Whitworth Street Planning Comparison

Since planning approval in 2016 the site has been purchased by Vision Manchester Limited. The client has engaged a full design team and RussellWBHO to update the detail design to the required regulations, agree a building contract and construct the development. Through this process a number of design changes are being proposed.

This updated document is being presented to Manchester City Council Planning Department to illustrate and explain the nature and extent of the proposed changes and to seek the Council's formal approval through the necessary planning process.

3.12 Proposed Typical Upper Floor Plan
(15th - 18th, 20th - 34th)

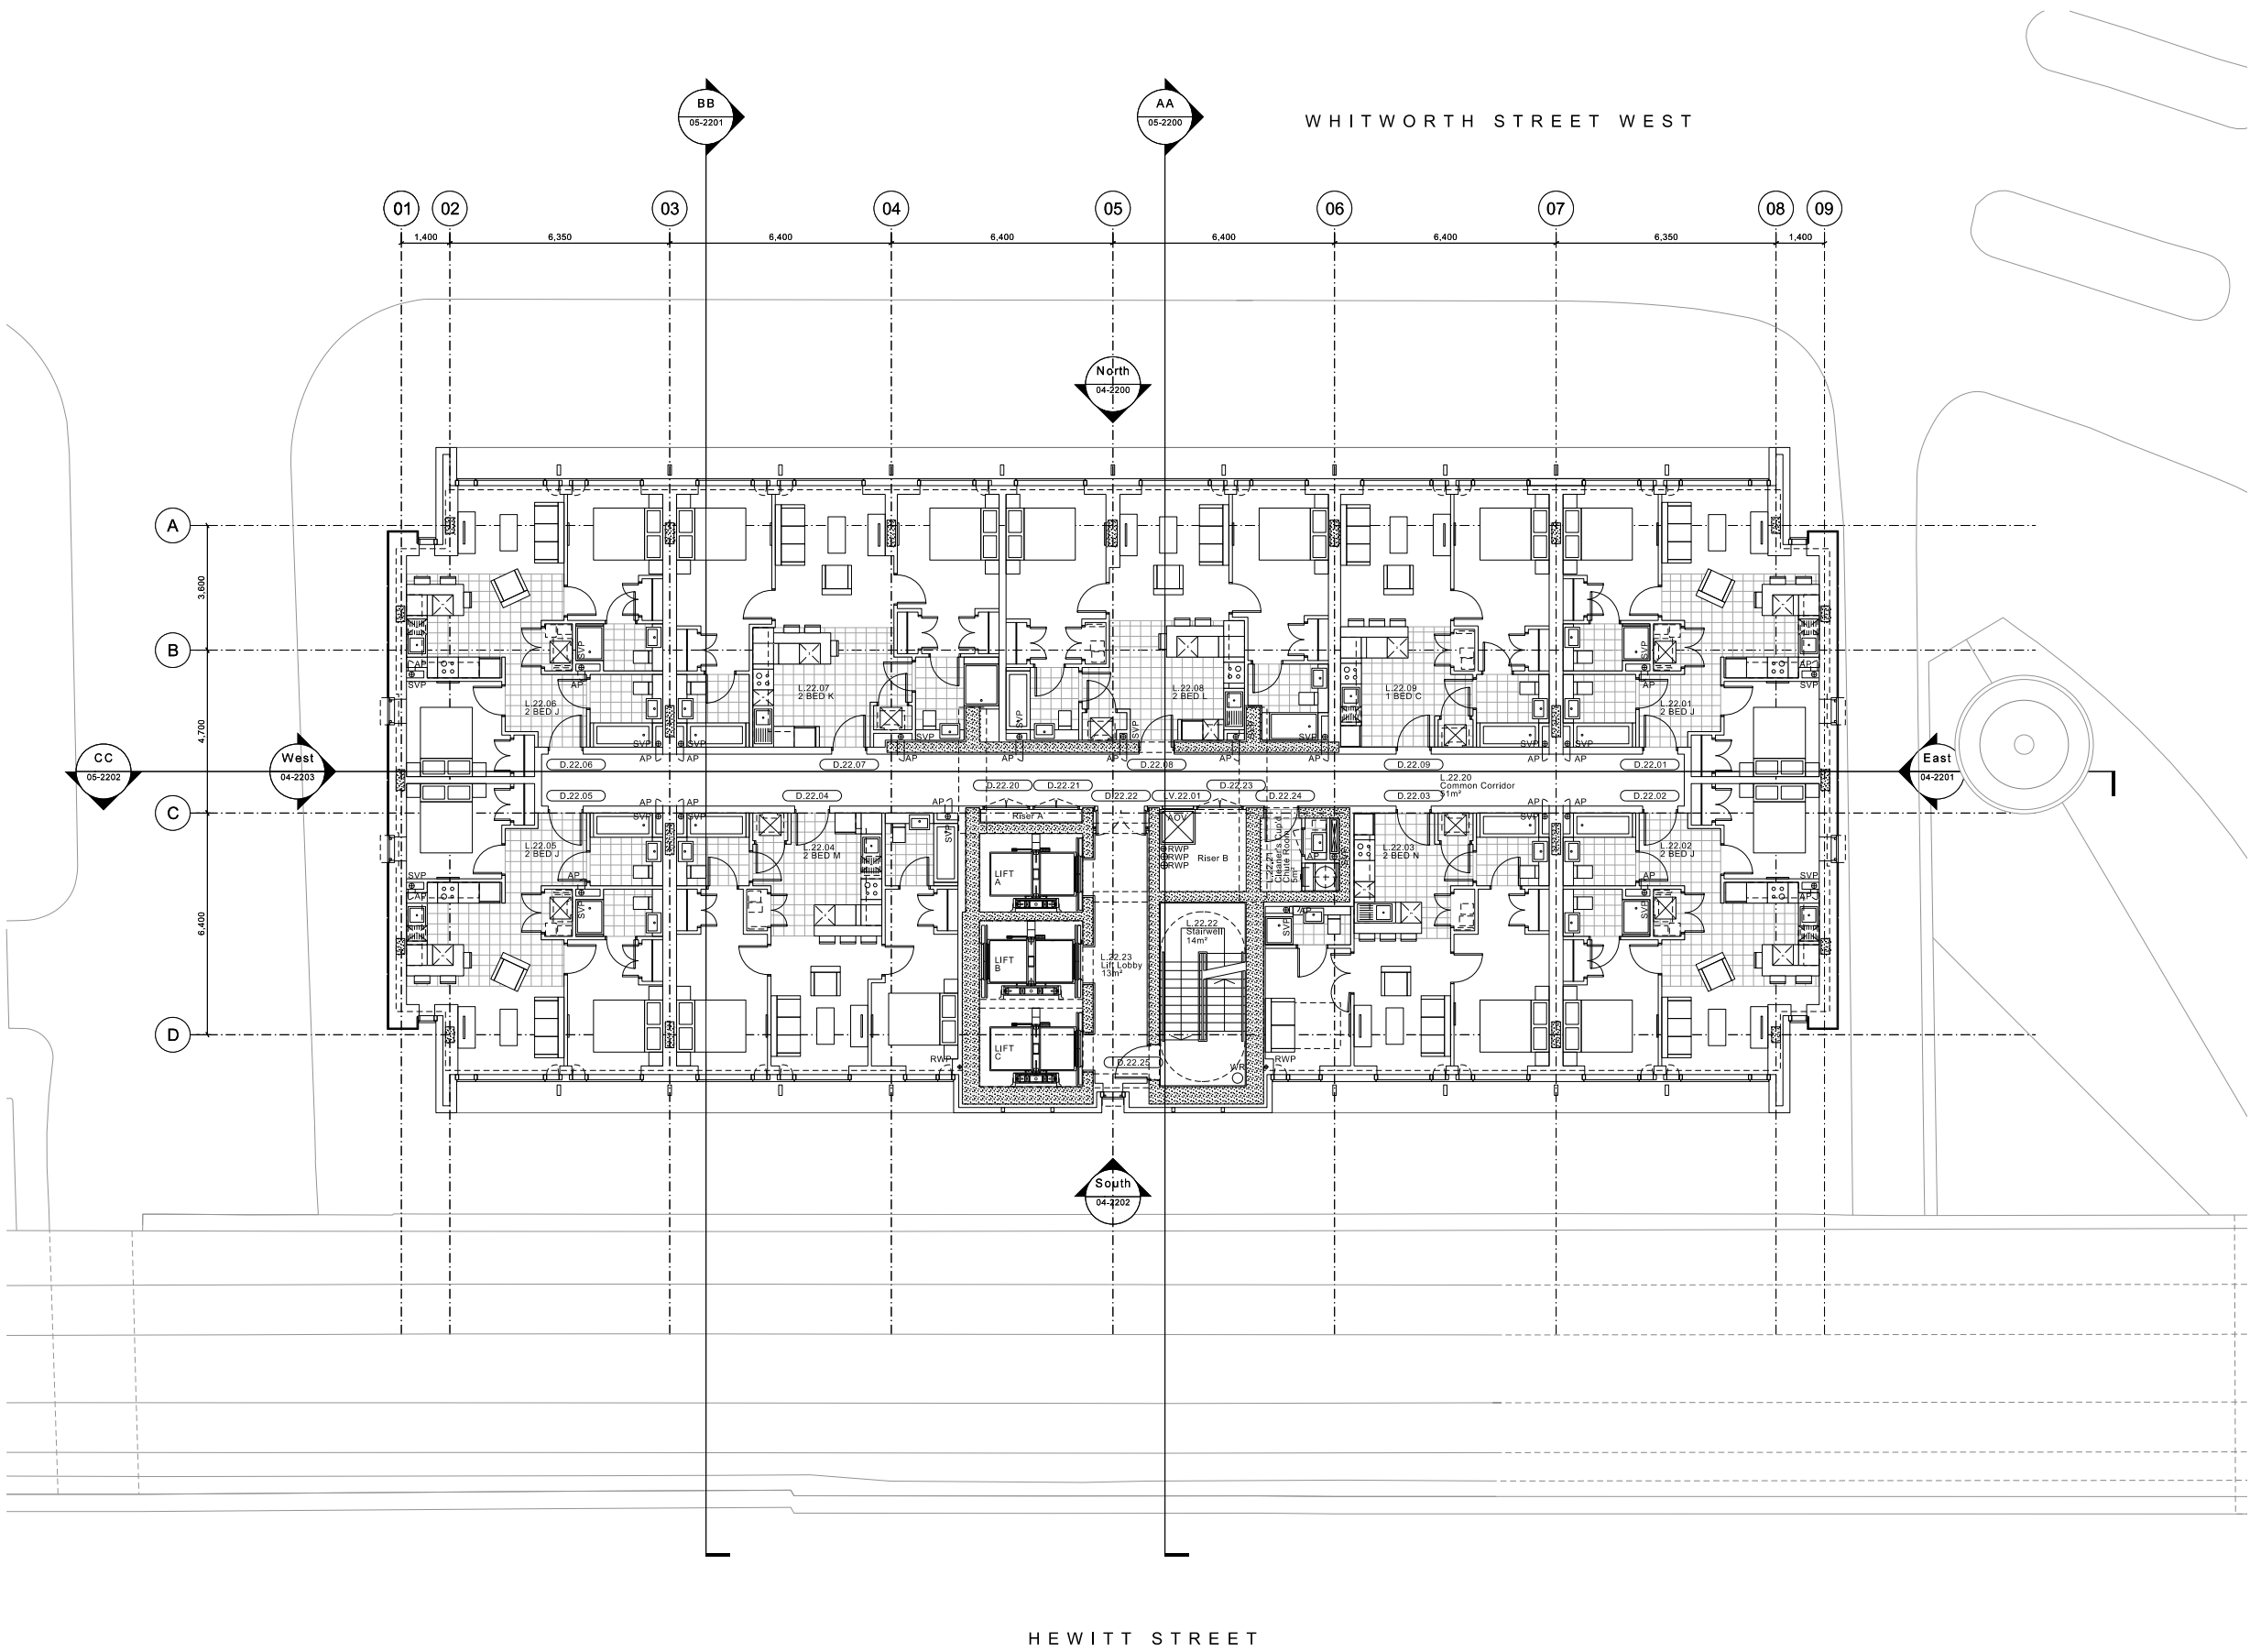
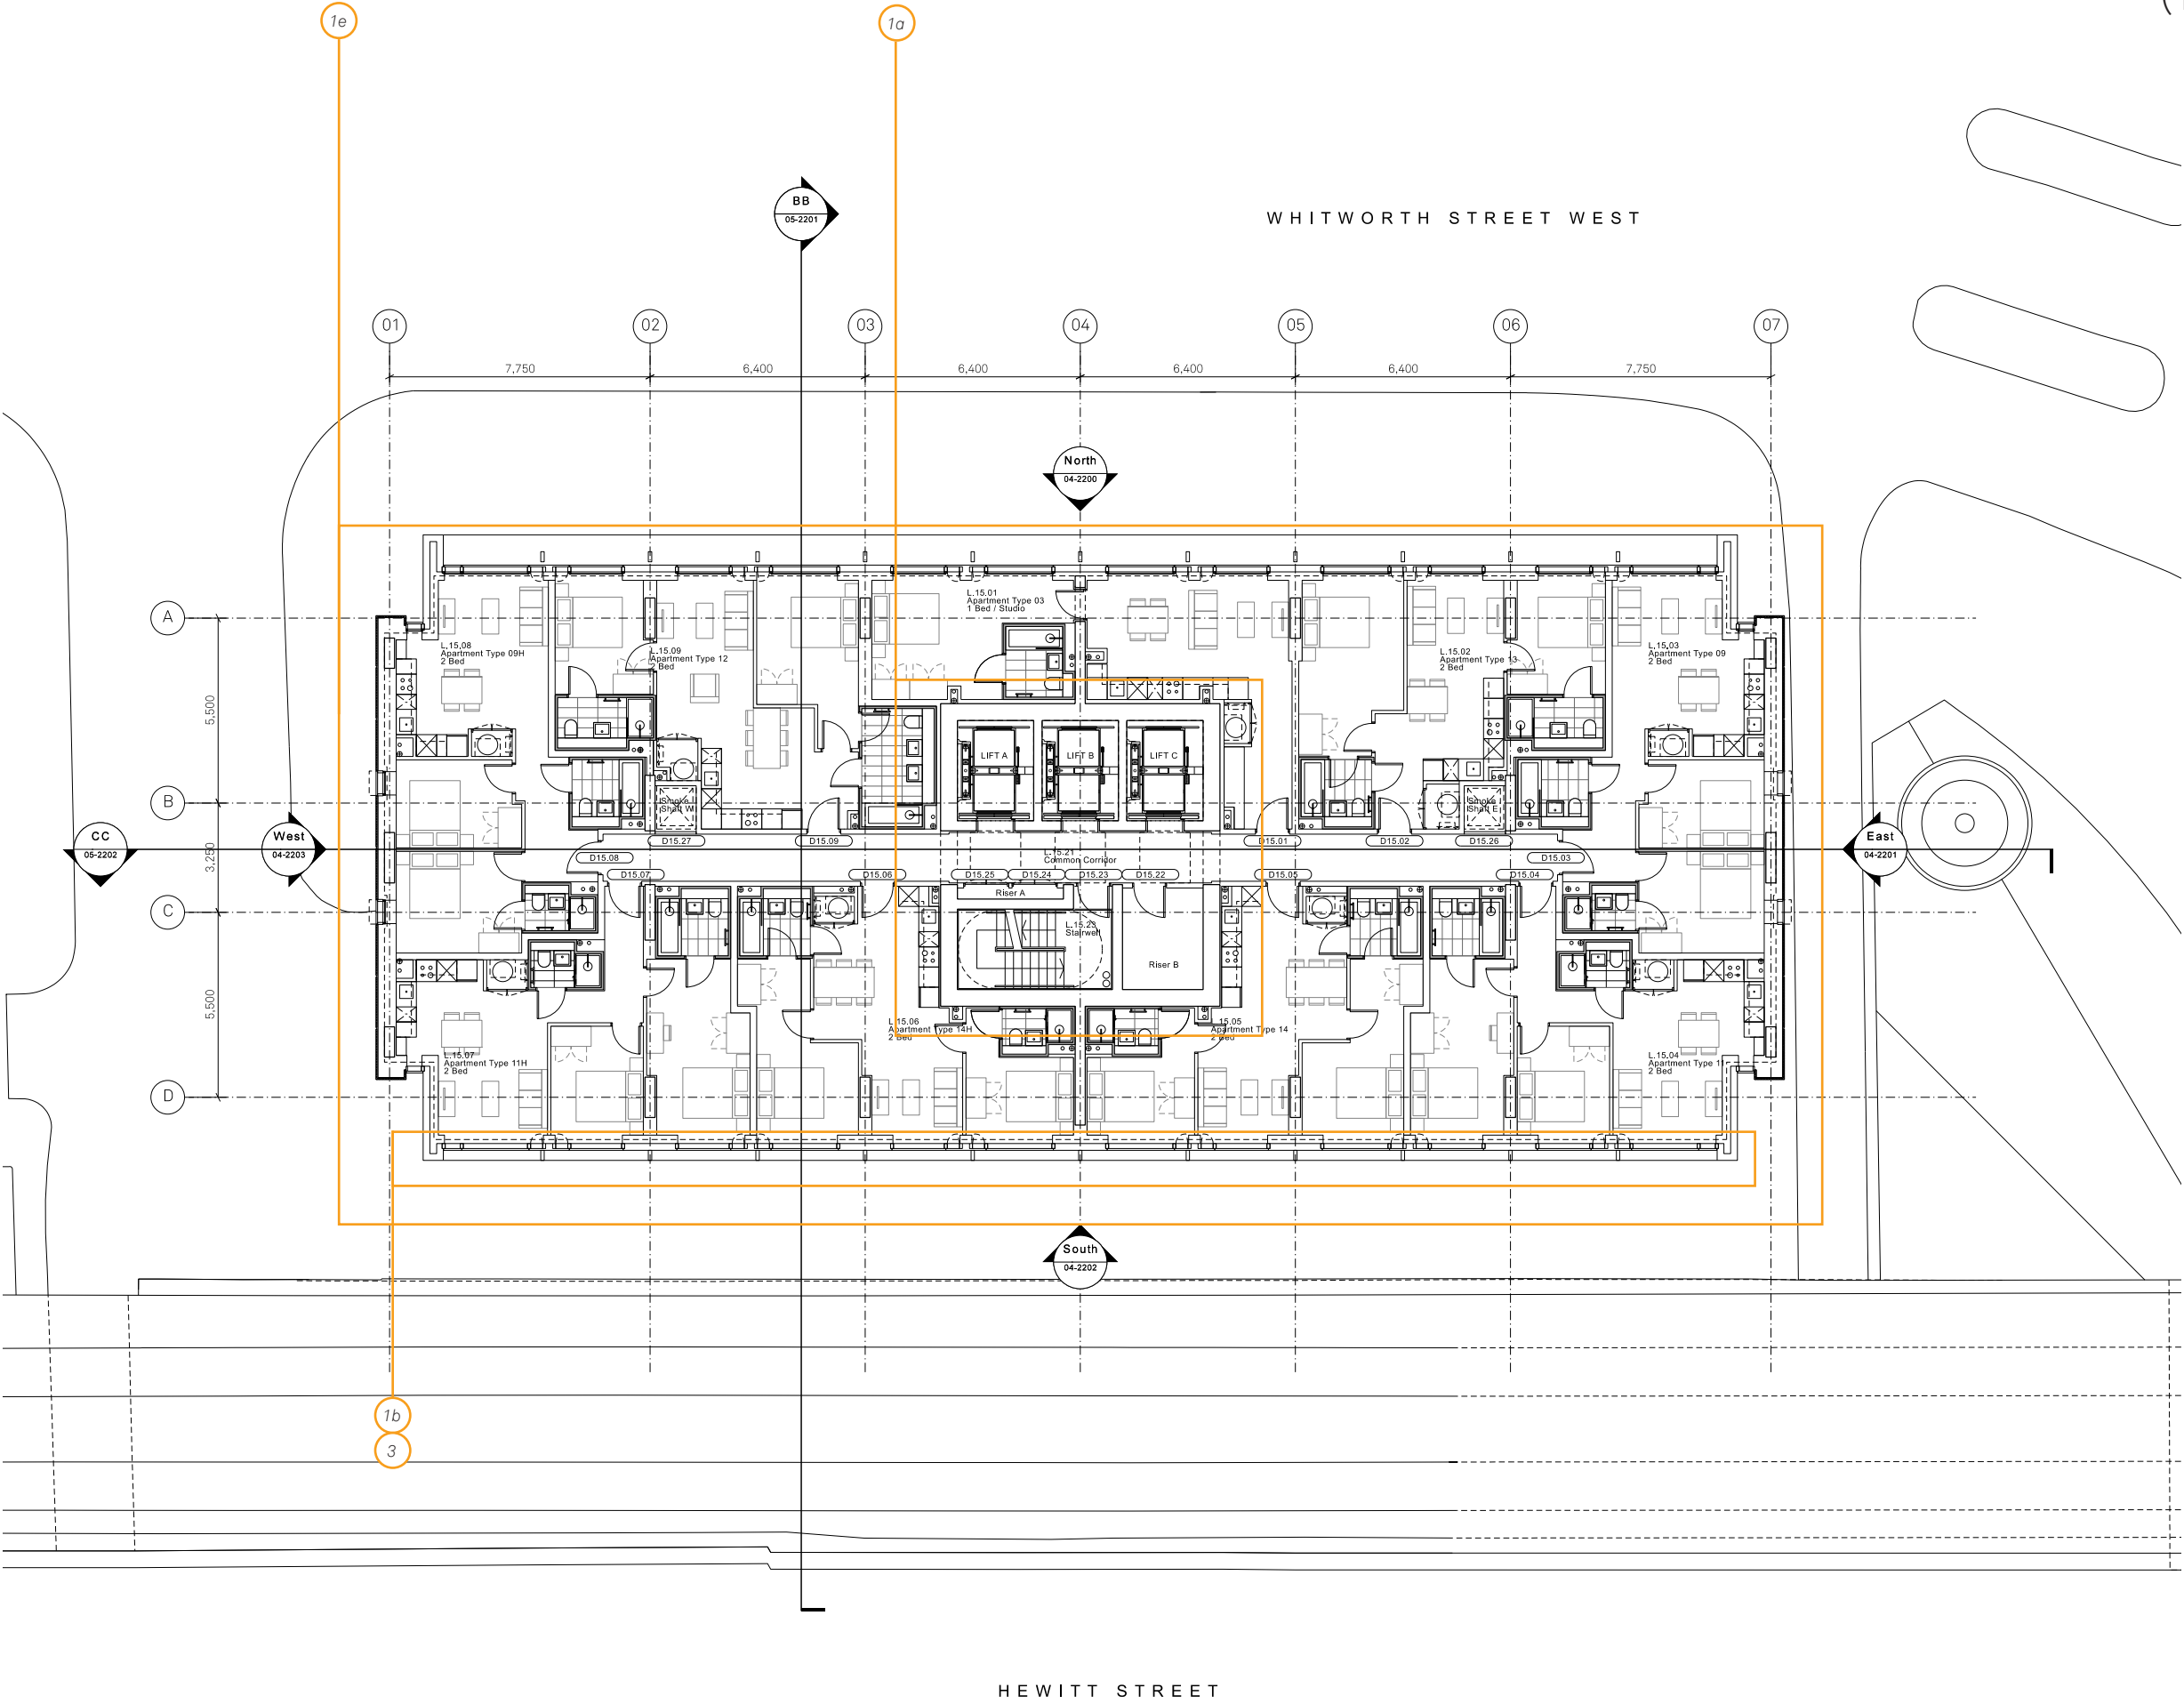
- 1a - Core Repositioned
- 1b - Main body of south facade to match north facade
- 1c - Entrance relocation
- 1d - Form of roof pavilion
- 1e - Apartment & amenity layouts
- 1f - Inclusion of commercial unit & dedicated entrance
- 2a - Reduced floor to floor heights
- 2b - Additional floor
- 2c - 2 no. Guest Beds & 2 no. 1 Bed become 2 no. 2 Bed & 2 no. 3 Bed
- 3 - South 'picture frame' reveal depth reduced by 600mm

3.15 Proposed 36th Floor Plan

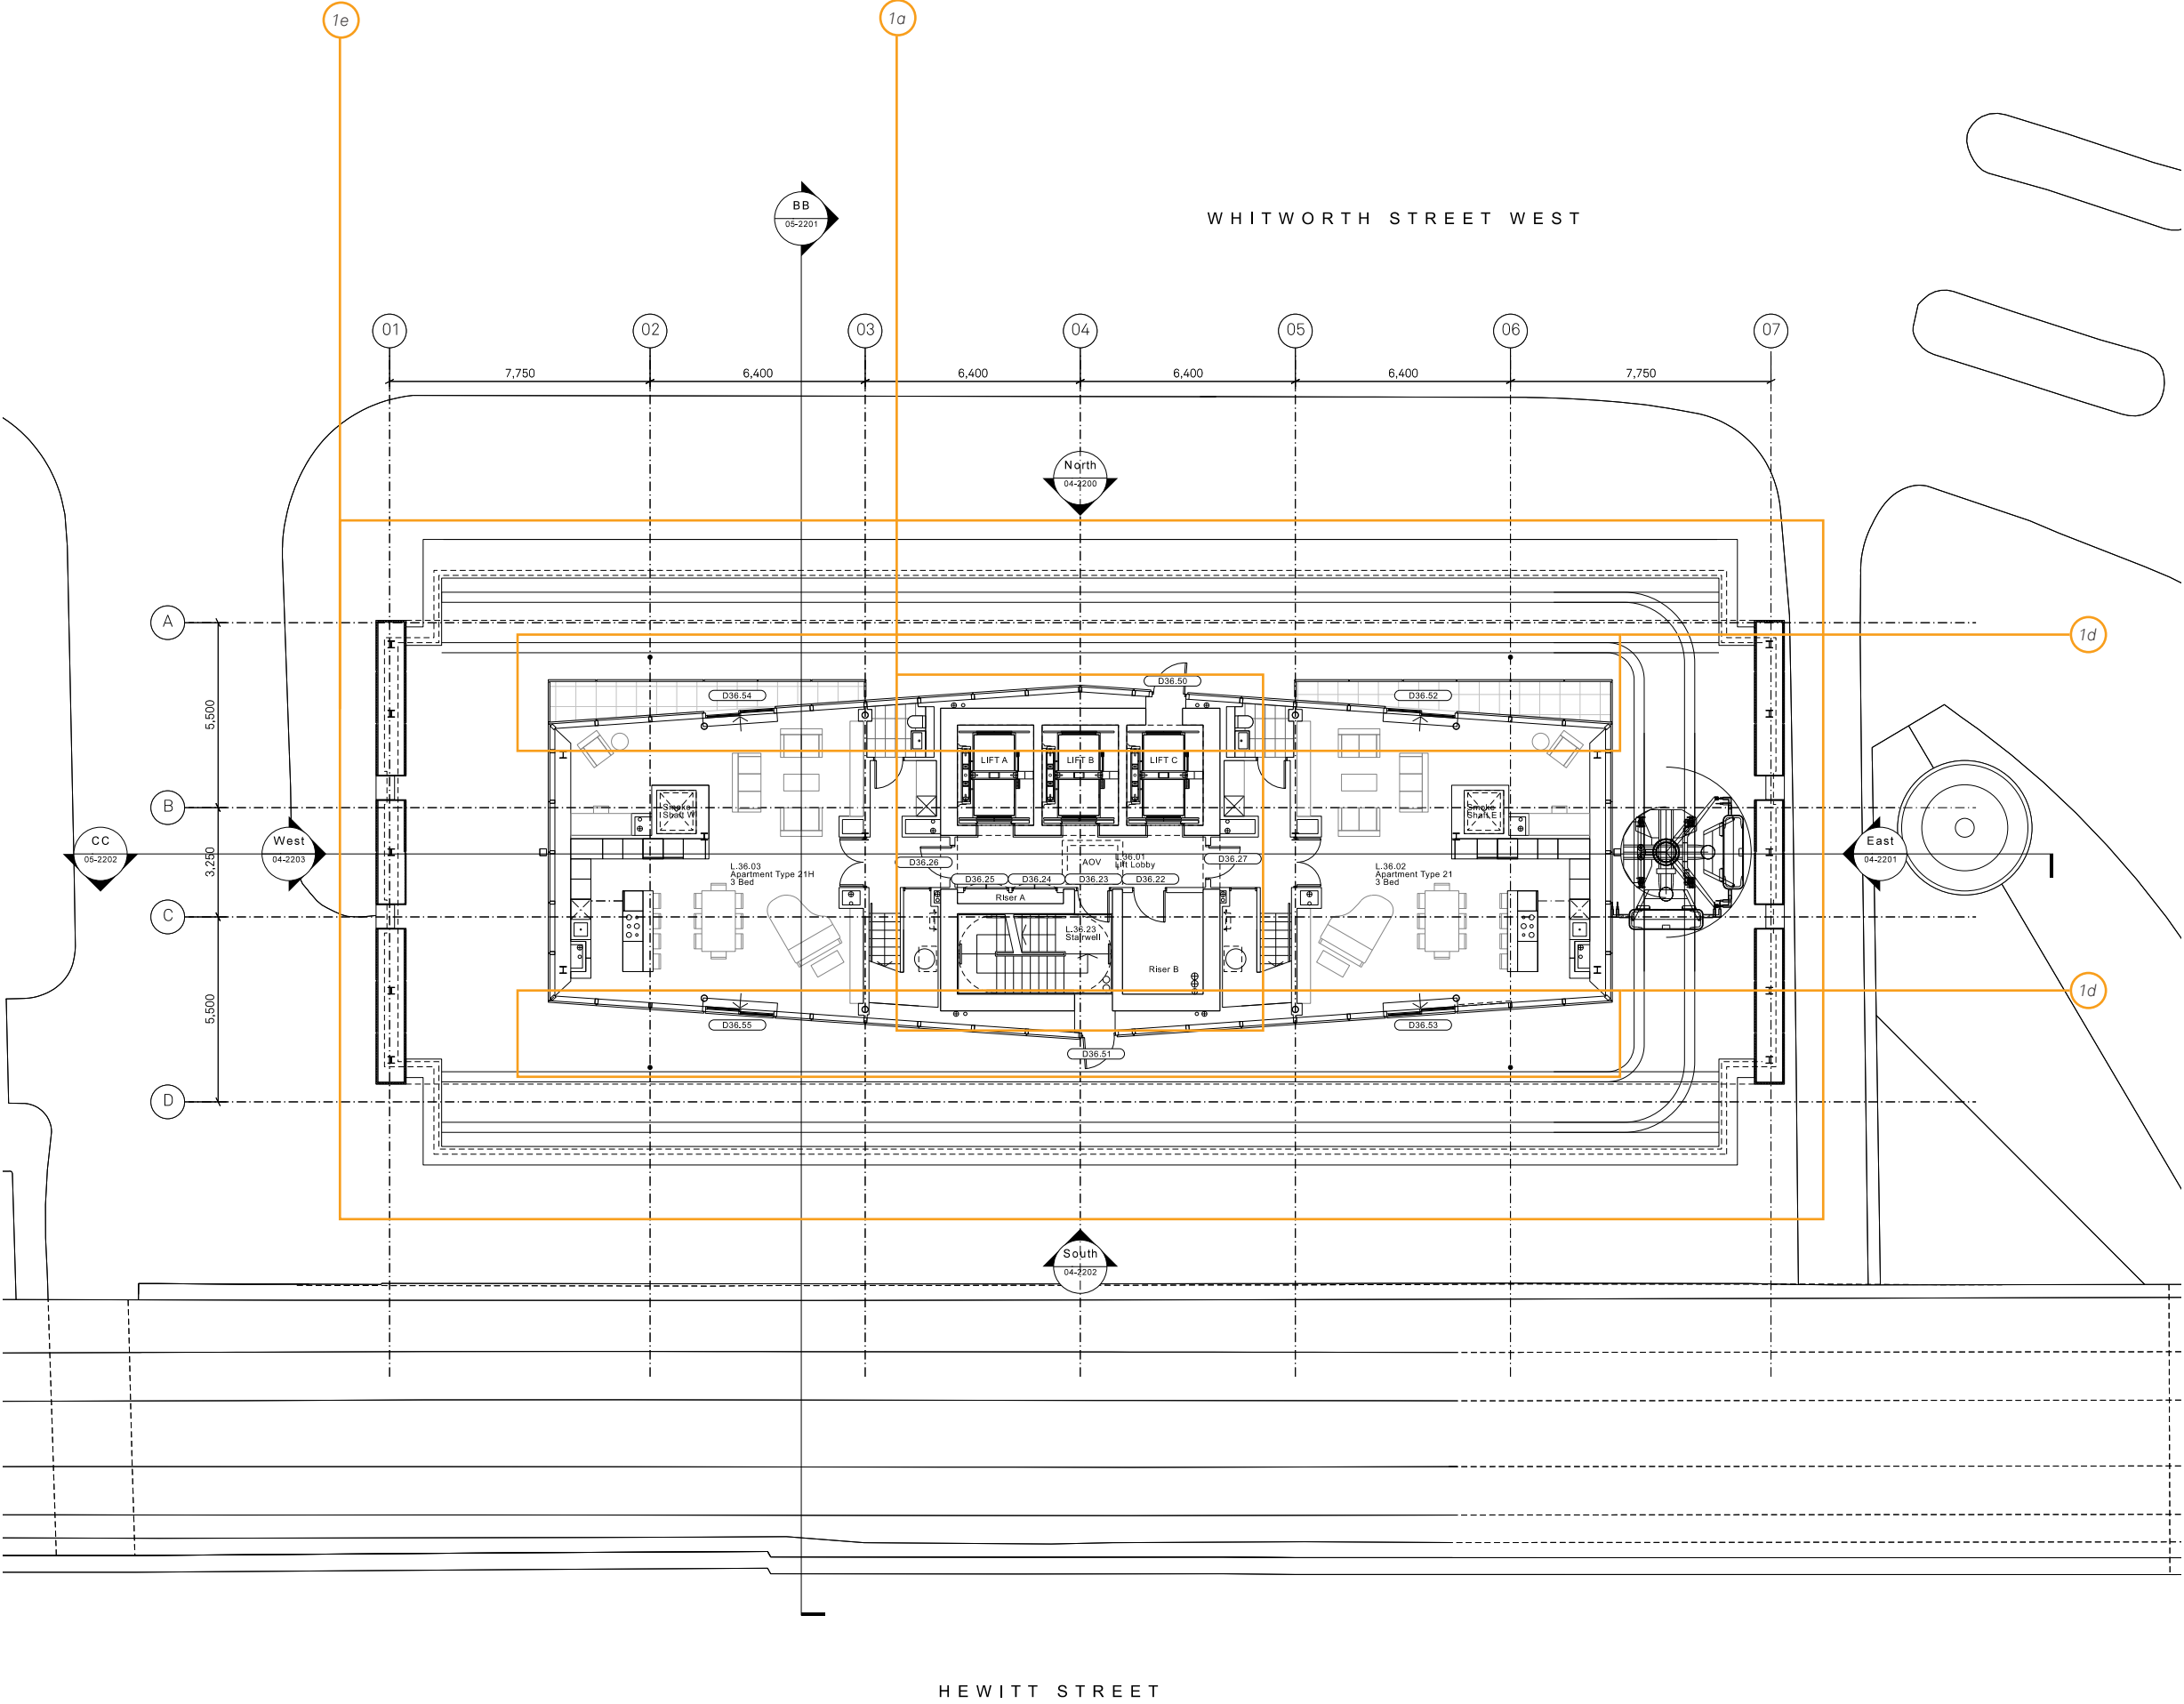
- 1a - Core Repositioned
- 1b - Main body of south facade to match north facade
- 1c - Entrance relocation
- 1d - Form of roof pavilion
- 1e - Apartment & amenity layouts
- 1f - Inclusion of commercial unit & dedicated entrance
- 2a - Reduced floor to floor heights
- 2b - Additional floor
- 2c - 2 no. Guest Beds & 2 no. 1 Bed become 2 no. 2 Bed & 2 no. 3 Bed
- 3 - South 'picture frame' reveal depth reduced by 600mm
